Title of Change:	The change is to improve product package robustness by changing of ICD2PAK 5LD from dual gauge to single gauge frame, add in mold lock on the heatsink and change mold compound from G600 to G700HF.
Proposed First Ship date:	01 Dec 2022 or earlier if approved by customer
Contact Information:	Contact your local onsemi Sales Office or AhmadFaris.Dzulkipli@onsemi.com
PCN Samples Contact:	Contact your local onsemi Sales Office. Sample requests are to be submitted no later than 30 days from the date of first notification, Initial PCN or Final PCN, for this change. Samples delivery timing will be subject to request date, sample quantity and special customer packing/label requirements.
Additional Reliability Data:	Contact your local onsemi Sales Office or AbdulRasyid.Ruslan@onsemi.com
Type of Notification:	This is a Final Product/Process Change Notification (FPCN) sent to customers. FPCNs are issued 90 days prior to implementation of the change. onsemi will consider this change accepted, unless an inquiry is made in writing within 30 days of delivery of this notice. To do so, contact PCN.Support@onsemi.com

PACKAGE: ICD2PAK 5LD

Final Product/Process Change Notification

Do

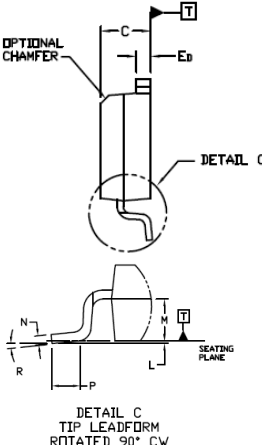
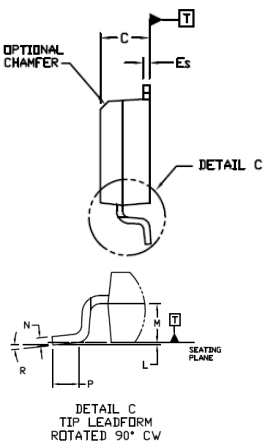
To notify customers of the change in leadframe supplier from KOBE to SDI, heatsink thickness from 50mils to 20mils, add in mold lock design on heatsink and change mold compound from G600 to G700HF. The change is to improve product package robustness.

Item	Before Change Description	After Change Description
LeadFrame	Heatsink thickness: Dual Gauges (50mils) Heatsink area: No mold lock	Heatsink thickness: Single Gauge (20mils) Heatsink area: add in mold lock
Mold Compound	G600	G700HF
Package case outline	 DETAIL C TIP LEADFORM ROTATED 90° CW CASE 936A-02 Issue D Heatsink Thickness E_D: 1.143-1.397mm Package thickness (C): 4.318-4.572mm	 DETAIL C TIP LEADFORM ROTATED 90° CW CASE 936A-02 Issue E Heatsink Thickness E_S: 0.457-0.660mm Package thickness (C): 4.318-4.572mm *Detail C and all the other dimension remain same.
